OTN reference point considerations

Tom Huber, Nokia

01 December 2022

Comment #48

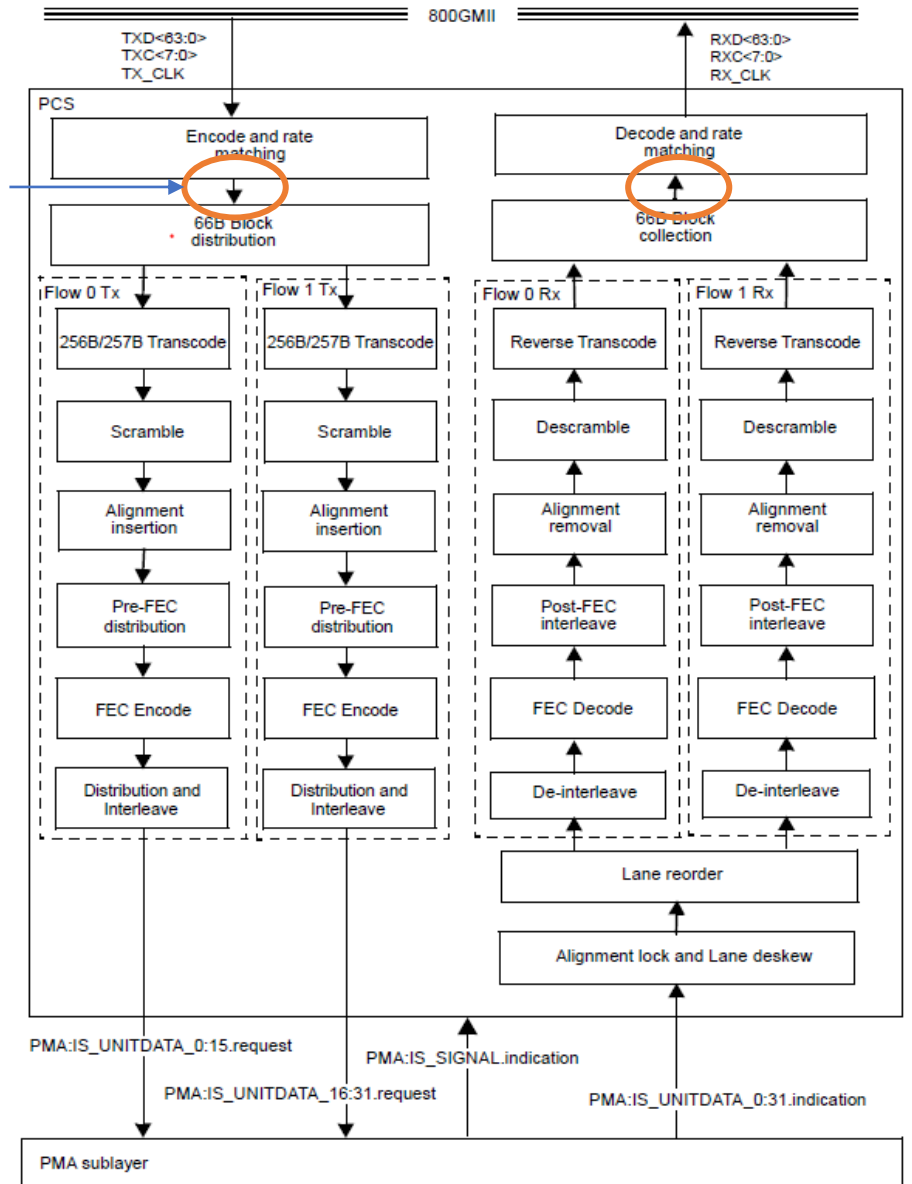
OTN reference point needs more discussion

- Text in 172.2.4.1 of 802.3df D1.0 indicates that the OTN mapping reference for 800GBASE-R is 66b blocks:
 - NOTE—The stream of 66-bit blocks generated by this process, together with the FEC_degraded_SER and rx_local_degraded bits should be used as the reference signal for mapping to OTN.
- This seems like a logical extension of 400GBASE-R, but it would be more desirable to map 257b blocks to OTN
 - All Ethernet PHYs 200G and faster are transmitted as 257b blocks
 - Using 66b blocks as the reference format for mapping to OTN creates a larger than necessary difference in bit rate between OTN and Ethernet signals
 - As bit rates go up, this makes it more difficult to use the same pluggable modules for both Ethernet and OTN signals, which has been an important capability for all rates since 10GBASE-R
 - There is market interest in “Ethernet-optimized” OTN rates

Alternatives to consider for 800GBASE-R - #1

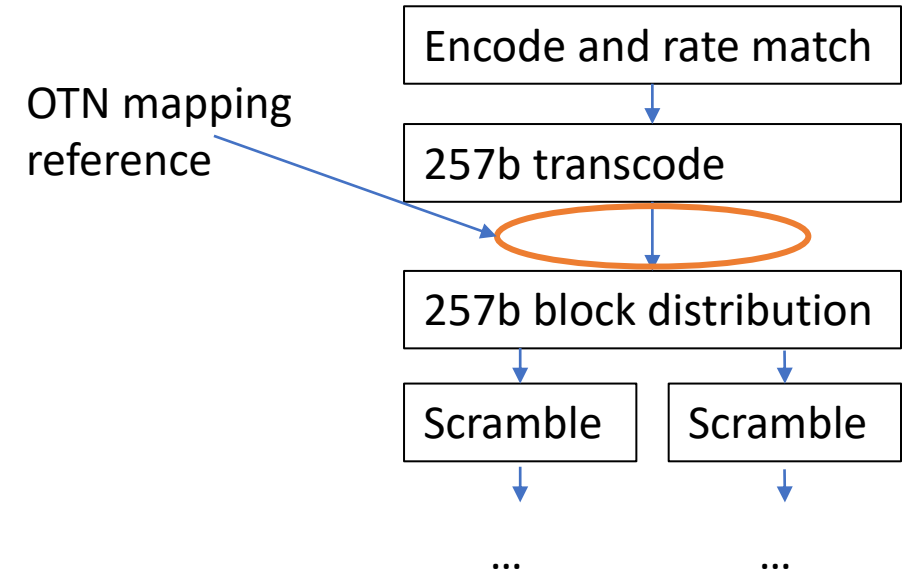
- Change the PCS to have a single transcoding process immediately after 66b encoding/decoding, and distribute 257b blocks to the two 400G flows
- Move the note from 172.2.4.1 to 172.2.4.2, and change the text:
 - NOTE—The stream of 257-bit blocks generated by this process, together with the FEC degraded SER and rx local degraded bits should be used as the reference signal for mapping to OTN.
- OTN reference point is independent of the two 400G flows (OTN mapper doesn't have to know about them)
- However, this would not interwork with ETC-800G-R since the association of 66b blocks to 257b blocks is different

Alternatives to consider for 800GBASE-R - #2

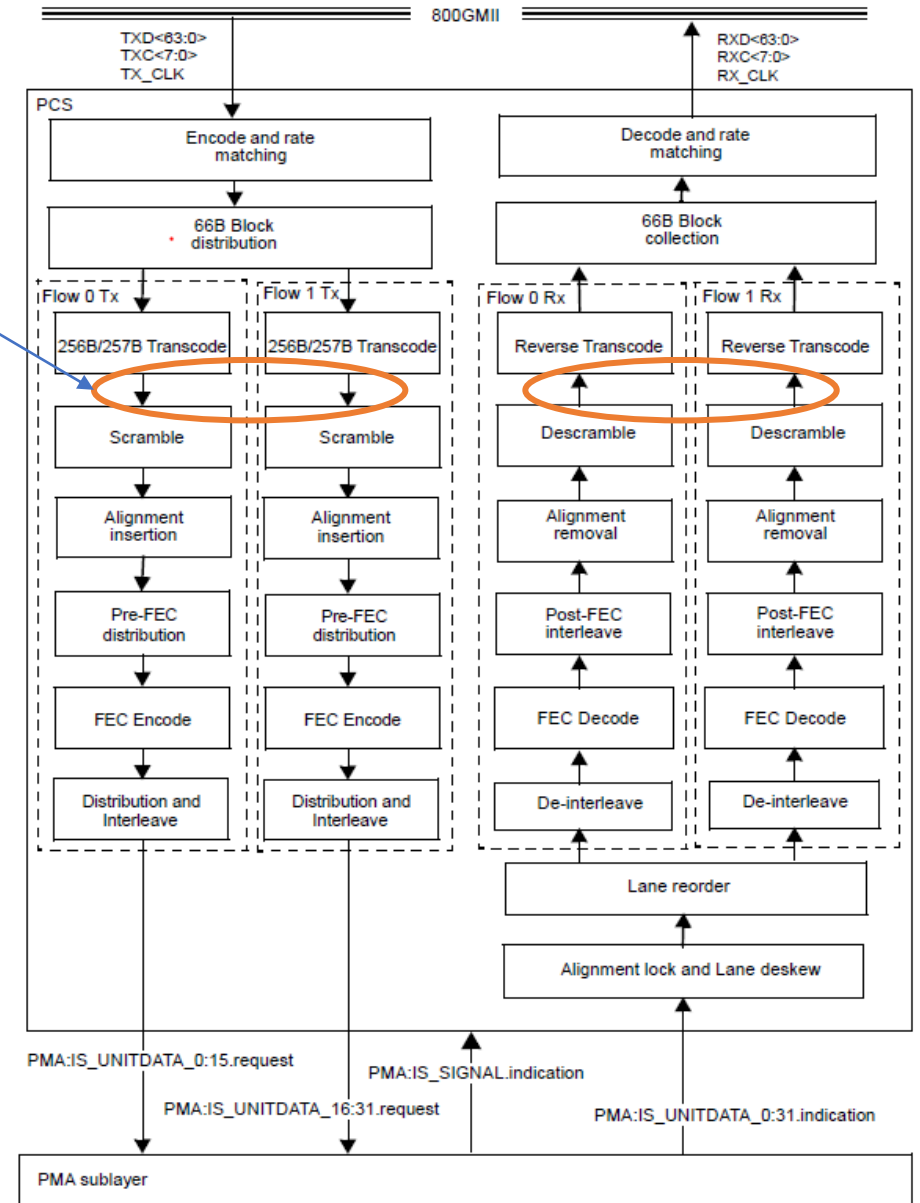
- Put the OTN mapping reference point after the 257b transcoding in each of the two flows
- Move the note from 172.2.4.1 to 172.2.4.2 and change the text:
 - NOTE—The **two** streams of **257-bit** blocks generated by this process, together with the FEC degraded SER and rx_local degraded bits, should be used as the reference signal for mapping to OTN. **The details of how to combine the two streams of 257-bit blocks into a single stream are outside the scope of this document.**
- Aligns well with what OIF is doing in 800ZR to create a single stream of 257b blocks to be mapped into the 800ZR frame
- Maintains interworking between 800GBASE-R and ETC-800G-R
- However, this exposes the two 400G flows in the description of the OTN mapping

- Adopt 257b blocks as the format at the OTN mapping reference point
- Discuss and select between alternatives 1 and 2 for defining the OTN mapping reference point
 - The tradeoff is technical purity vs. interoperating with ETC-800G-R
 - The pragmatic solution would seem to be alternative #2
- Regardless of what decisions are taken, send a liaison to Q11/15 regarding the intended OTN mapping reference point for 800GBASE-R interfaces
 - Q11/15 next meets the week of 13 February, so this could come from the January 802.3 interim meeting
